MVEA YODER SUBSTATION

EL PASO COUNTY

SITE PLAN

MVEA YODER SUBSTATION
 SITE PLAN

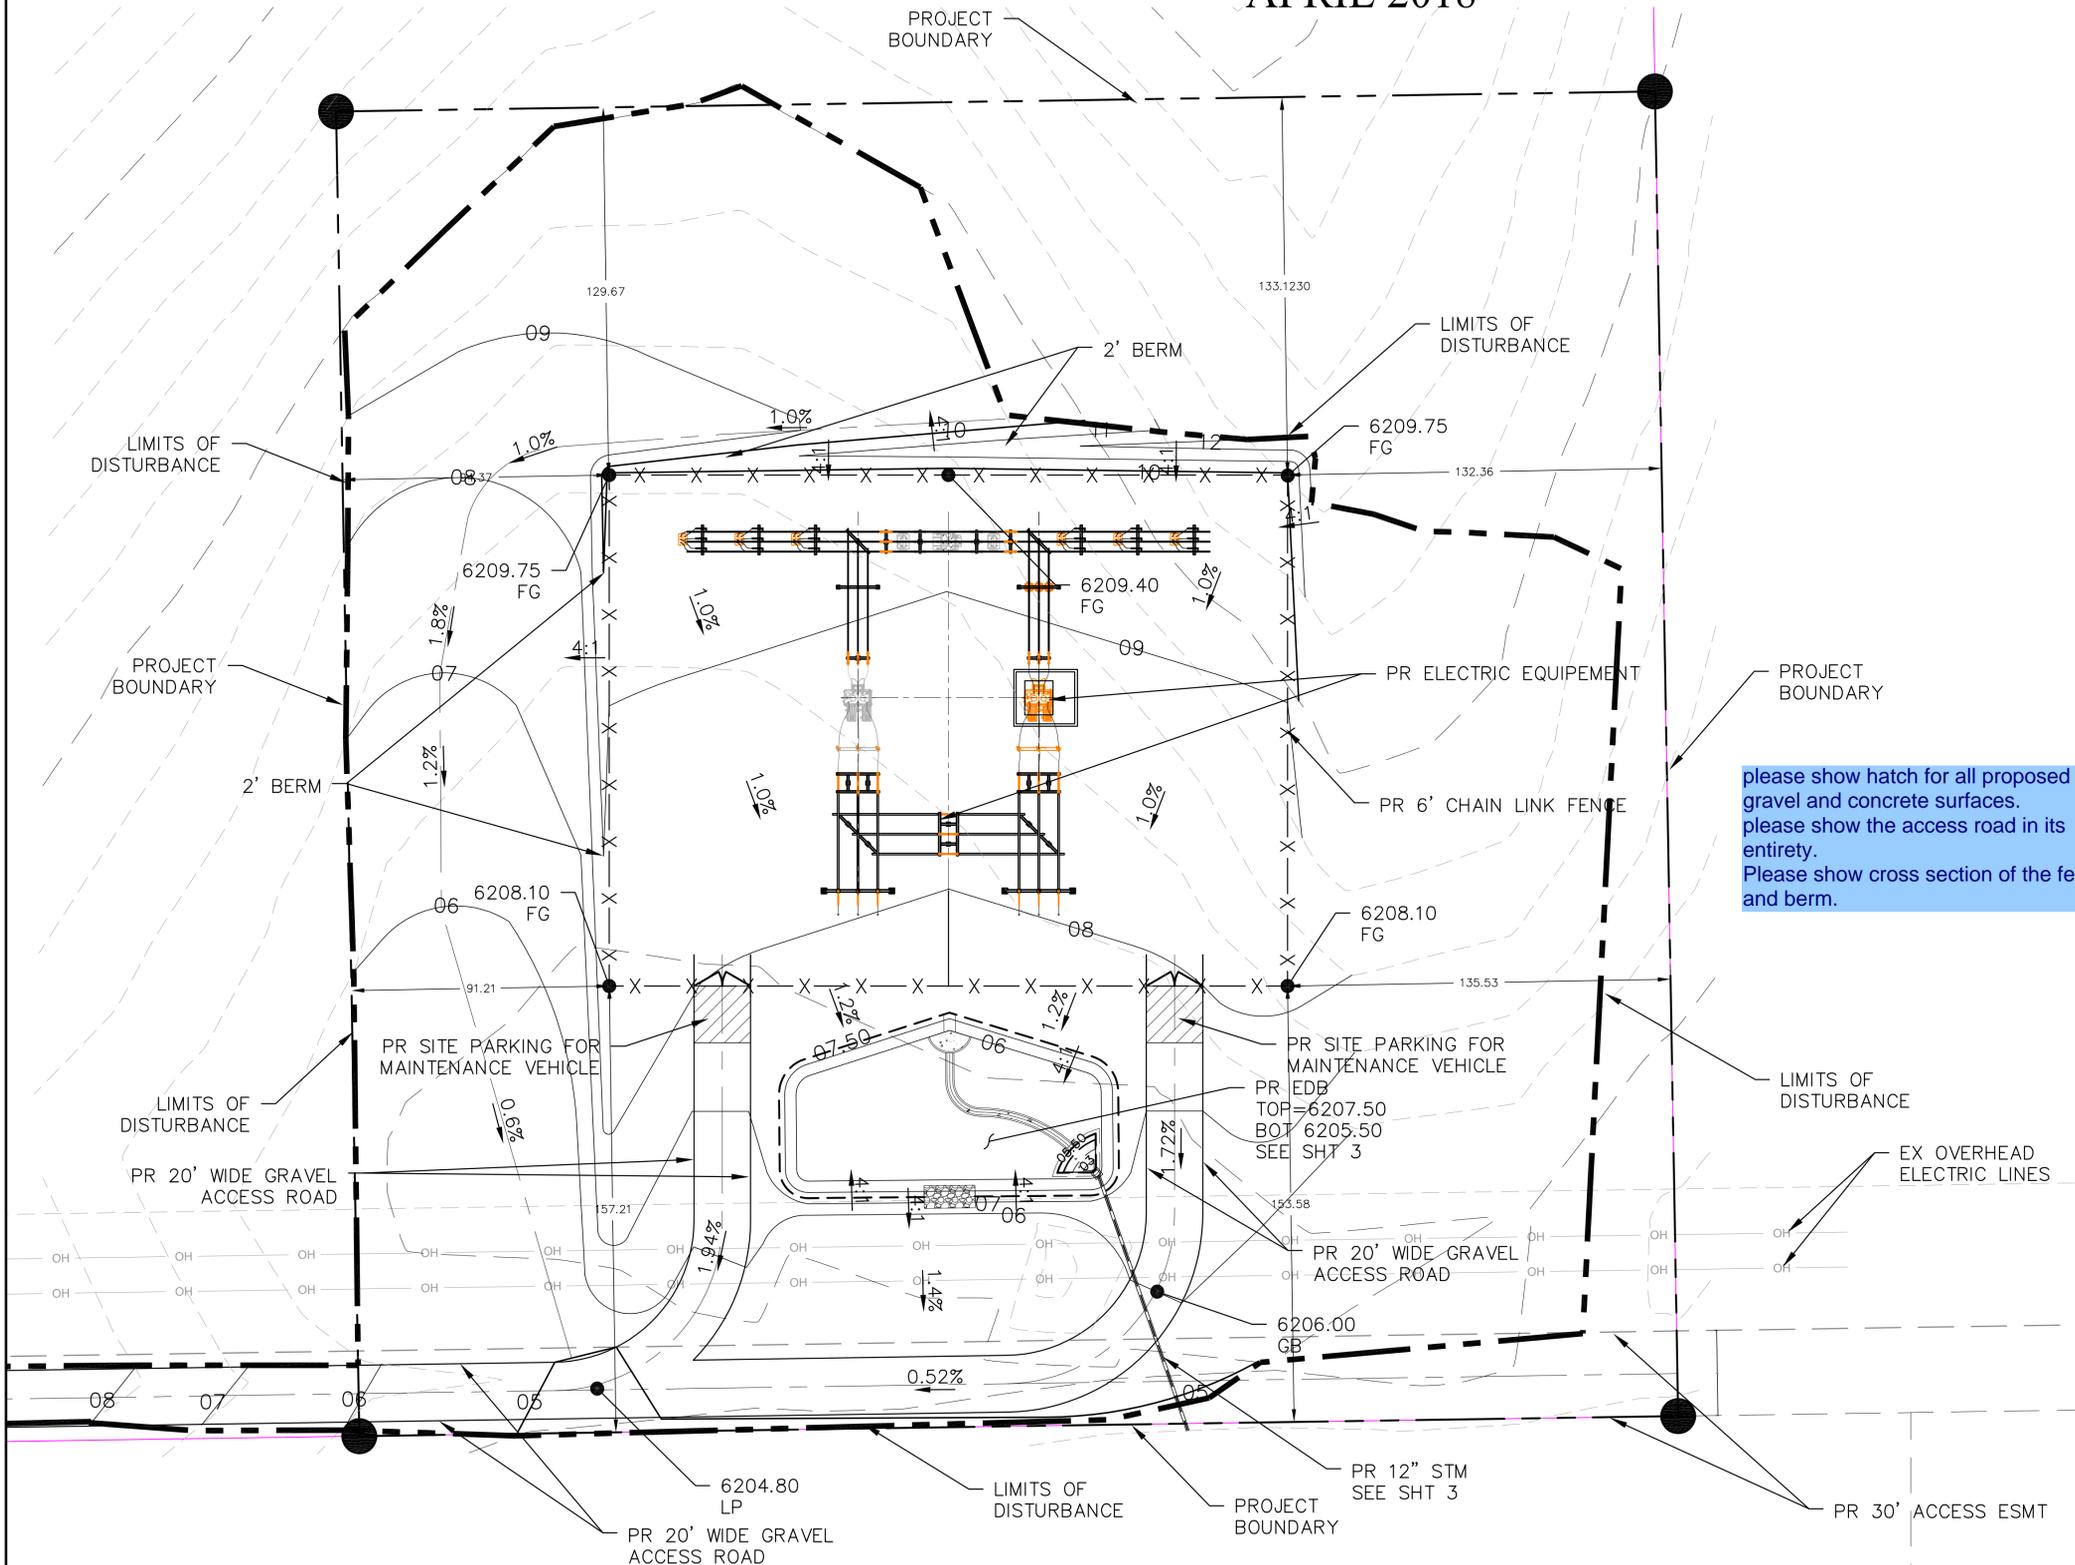
please show hatch for all proposed gravel and concrete surfaces.
 please show the access road in its entirety.
 Please show cross section of the fence and berm.

please show all existing fences on the southerly property line.
